Galloway Response
10/30/2024

MISTER CAR WASH

SITE CONSTRUCTION PLANS

STORM LINE 1 PLAN
SCALE: 1"=20'

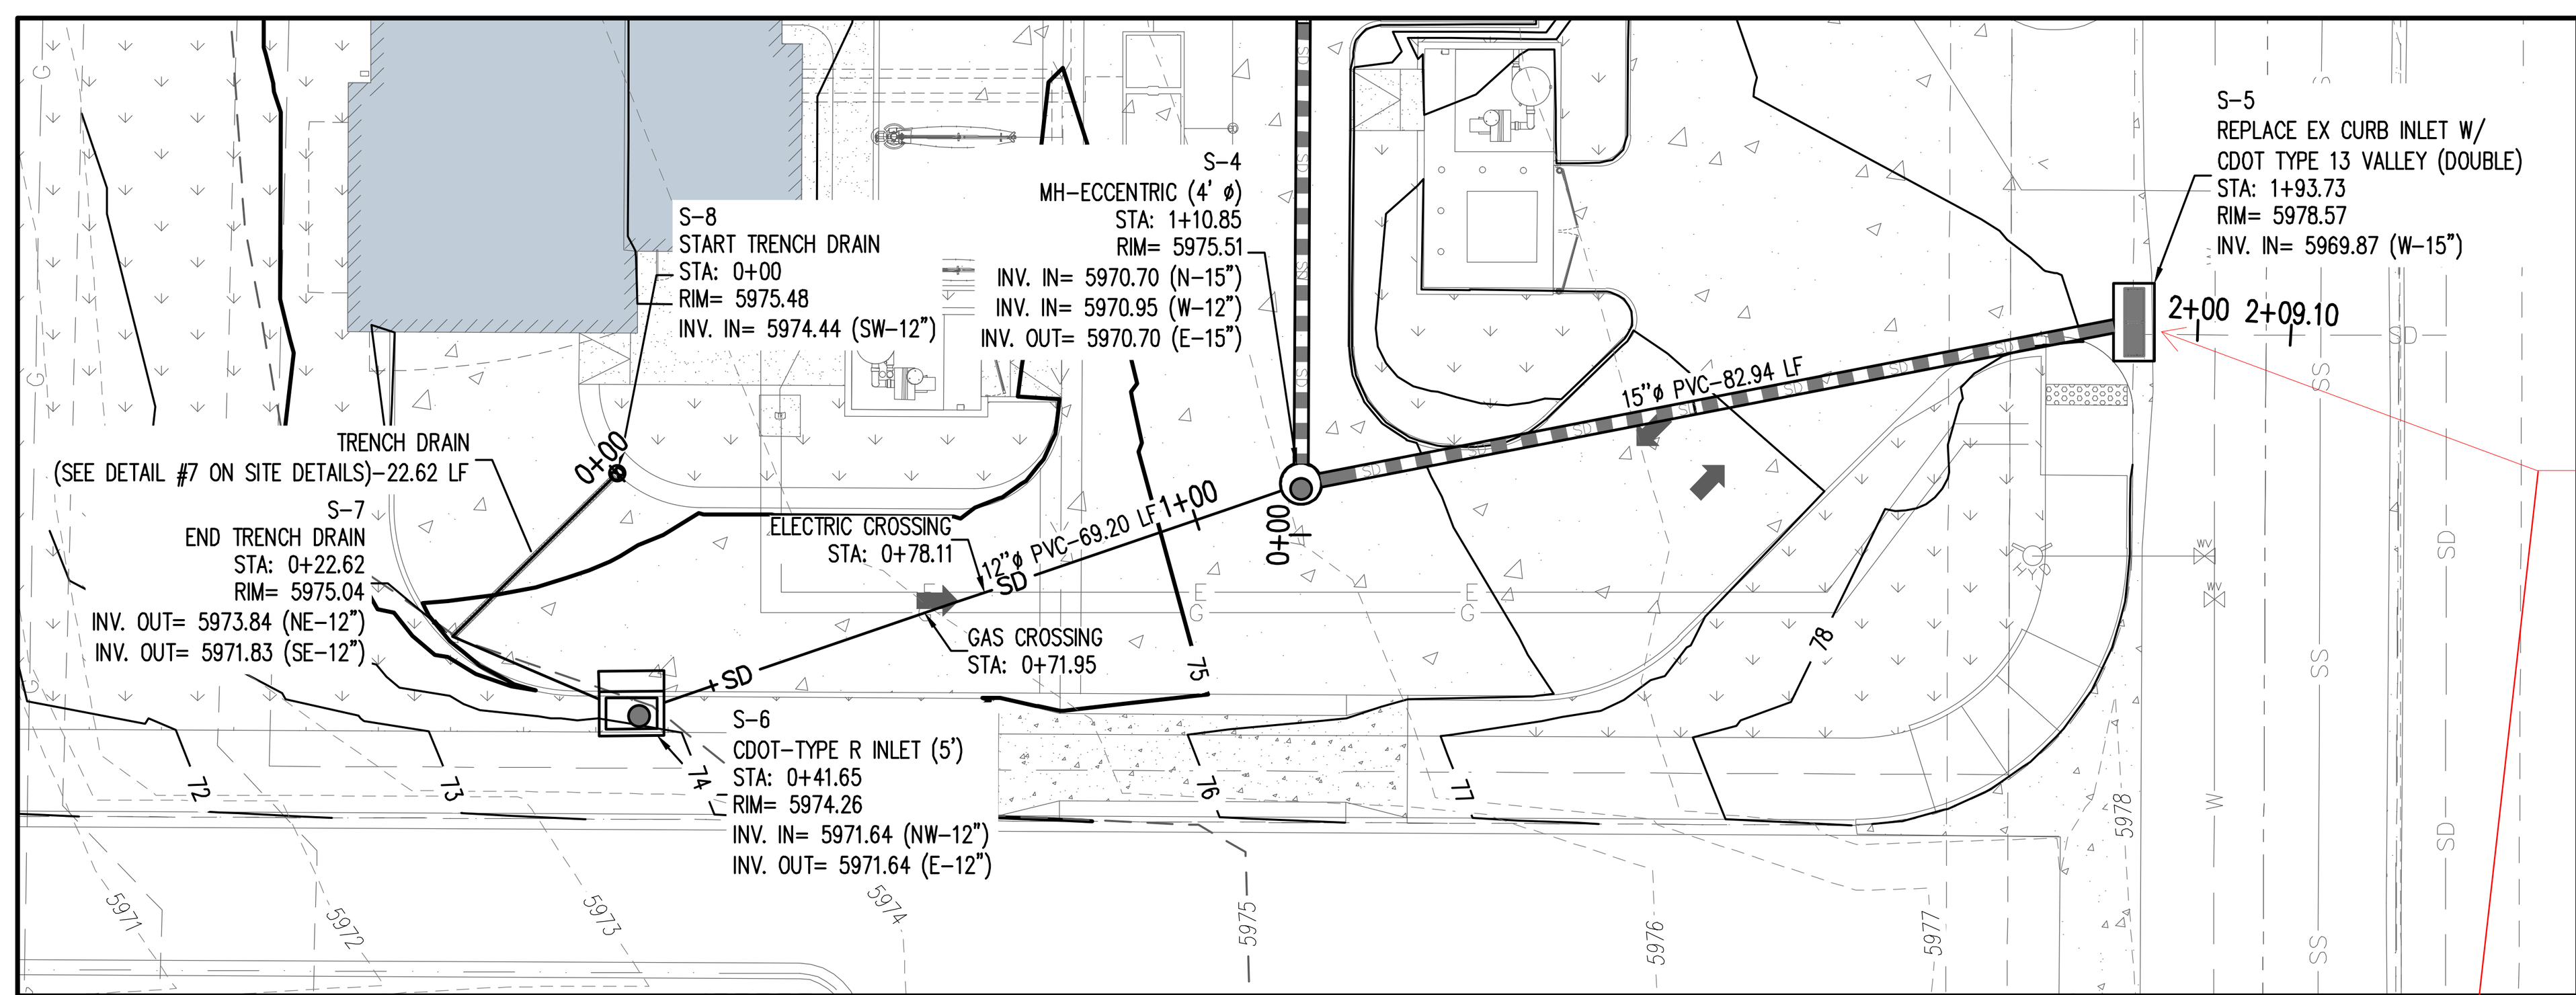
Provide the invert out information for tie-in to existing storm drain and show this information on the profile as well.

Existing invert has been called out on the plan and profile

STORM LINE 2 PLAN
SCALE: 1"=20'

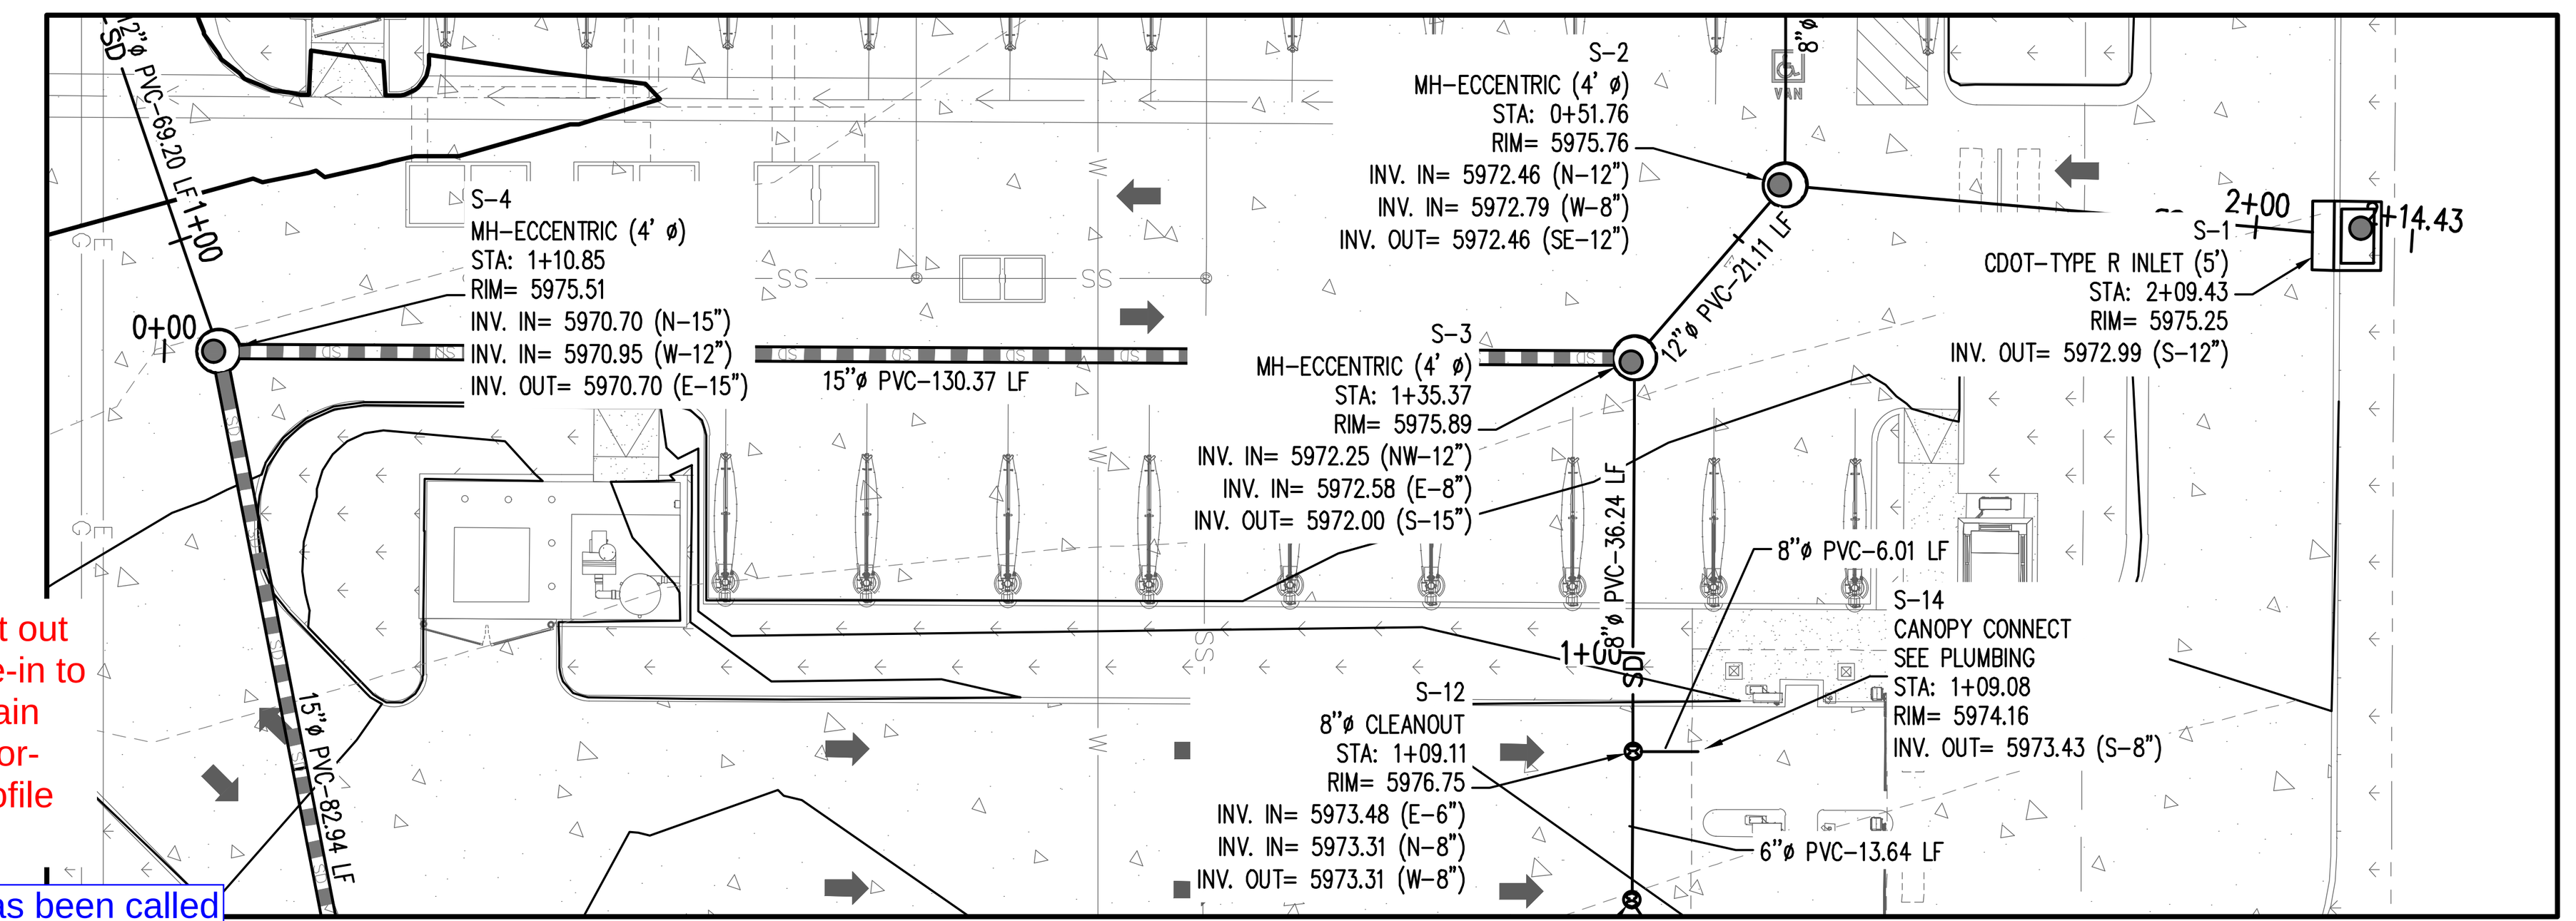
Please specify what dry utilities being located are.

STORM LINE 1 (STA: 0+00 TO 2+09.10) – SCALE: H: 1"=20' V: 1"=2'

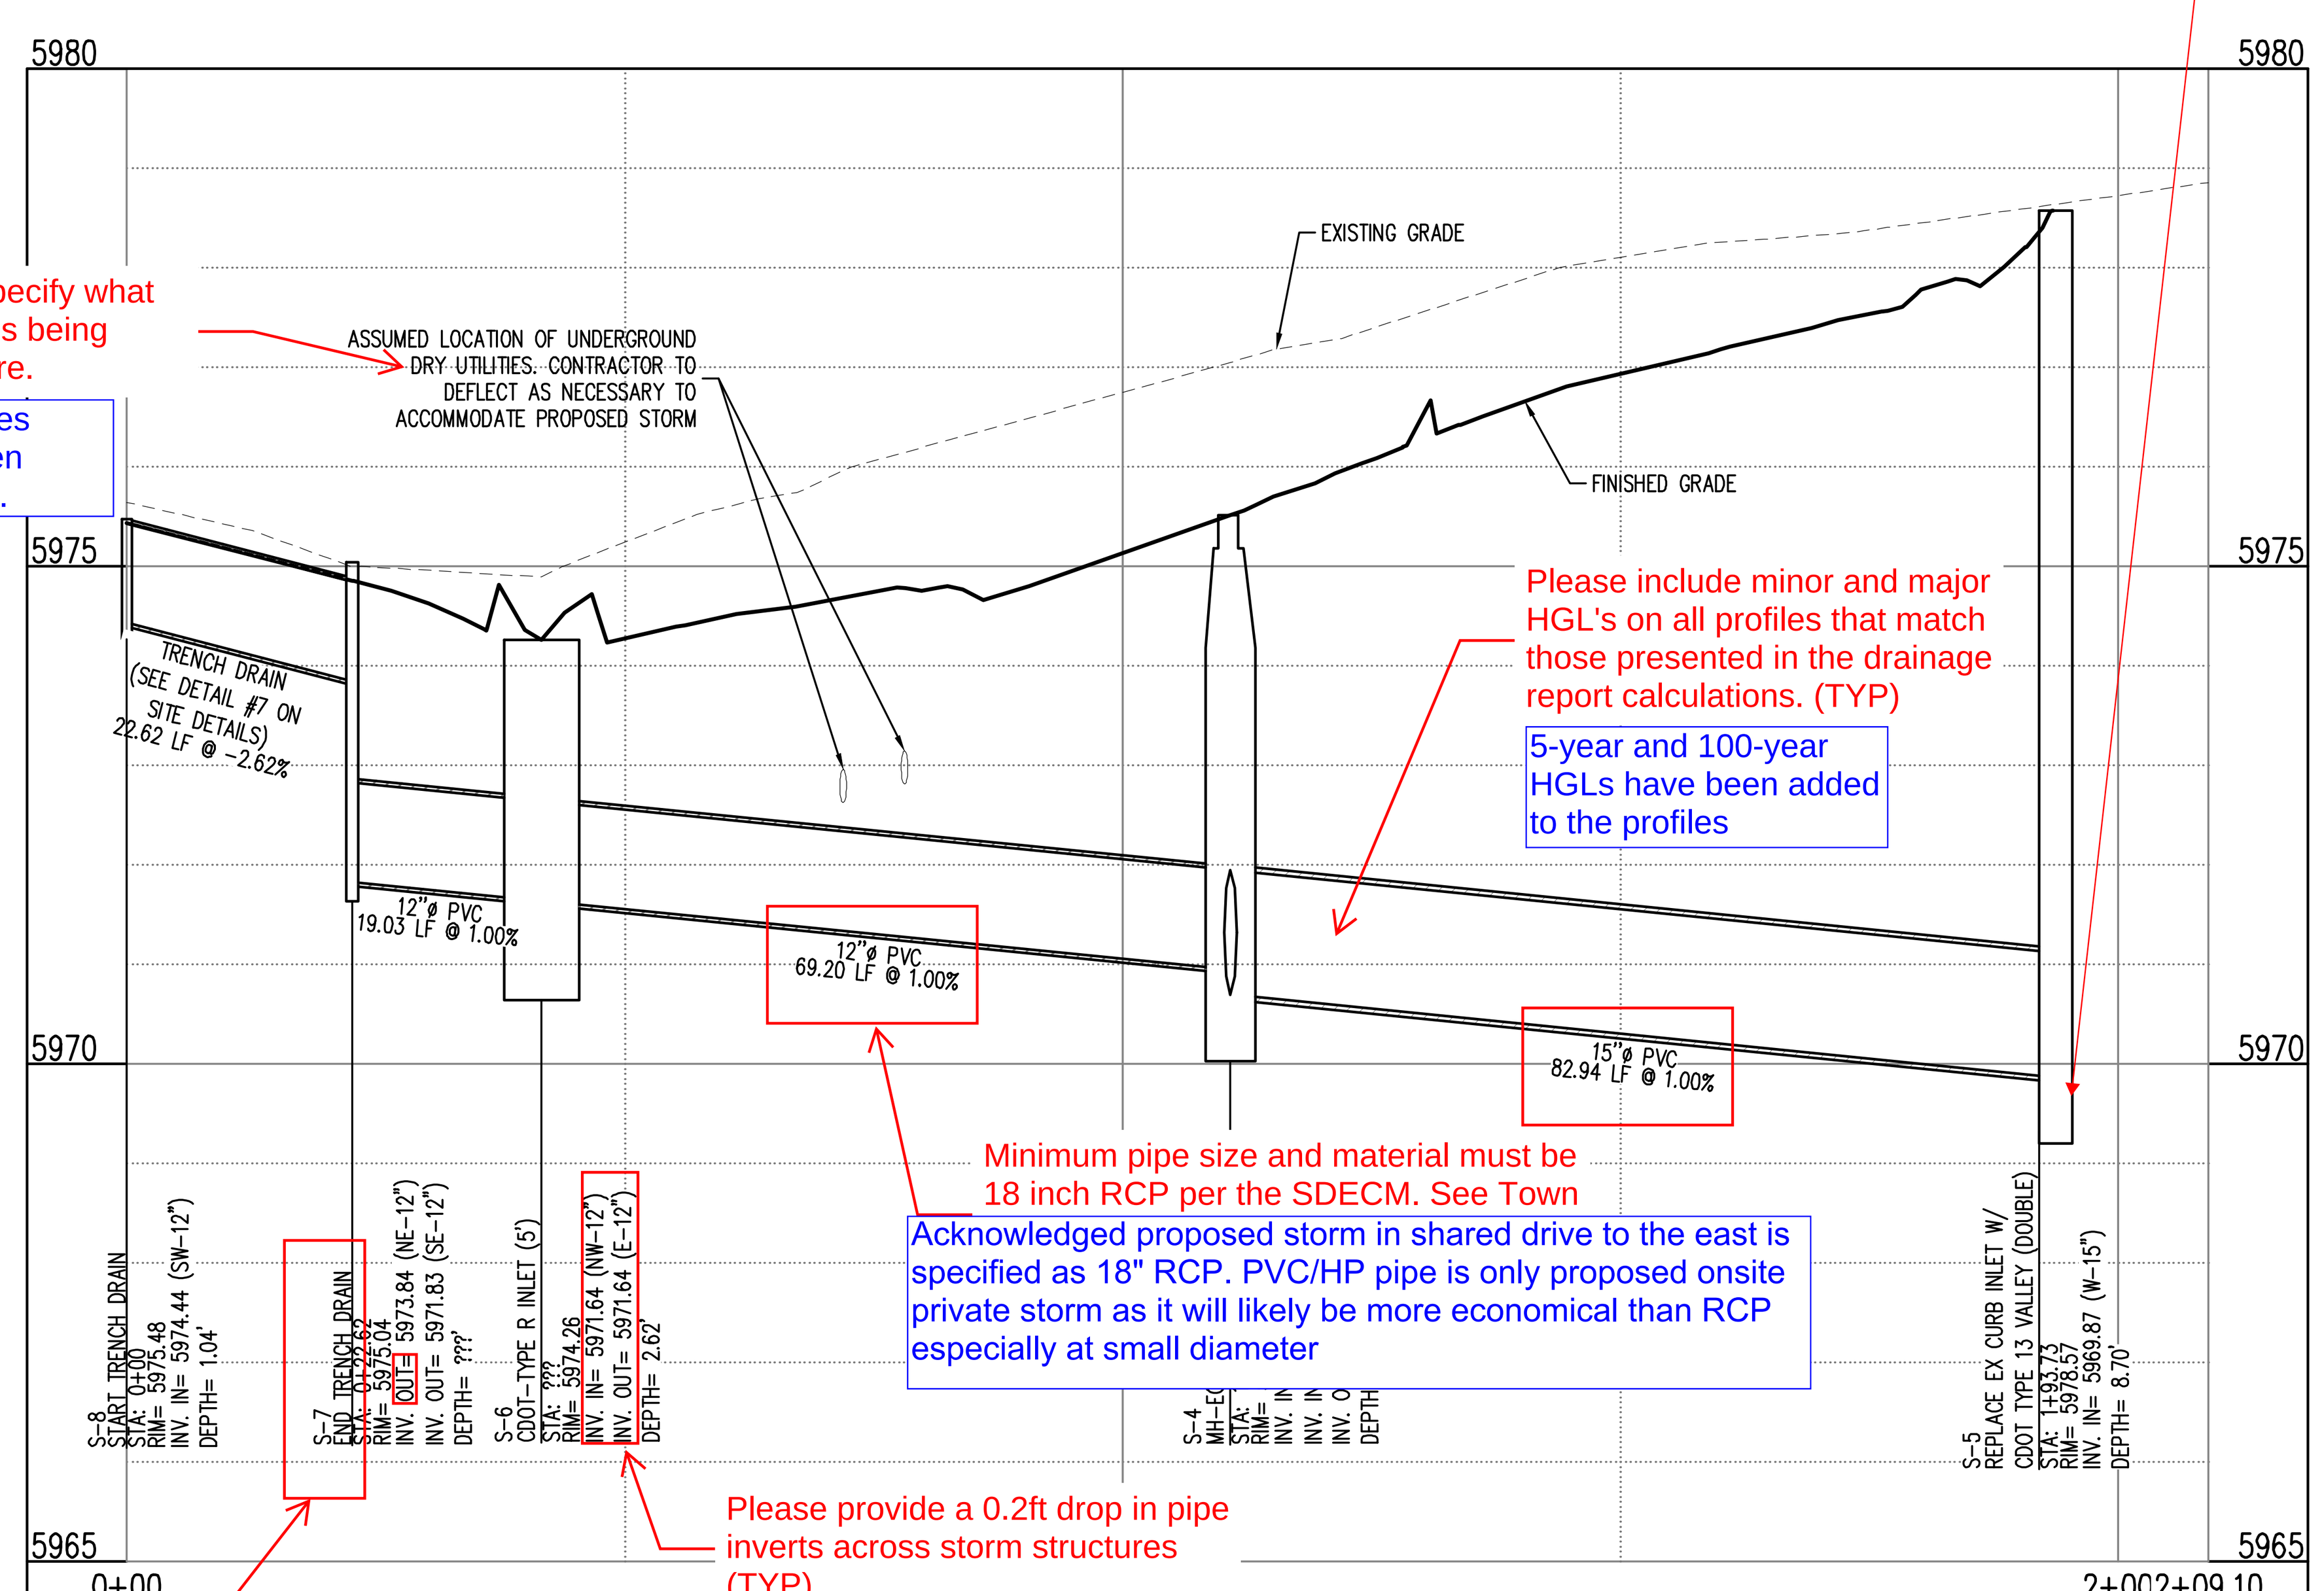
Please provide a 0.2ft drop in pipe inverts across storm structures (TYP)

0.2 ft drop has been added to all storm structures

0.2 ft drop has been provided for all storm manholes
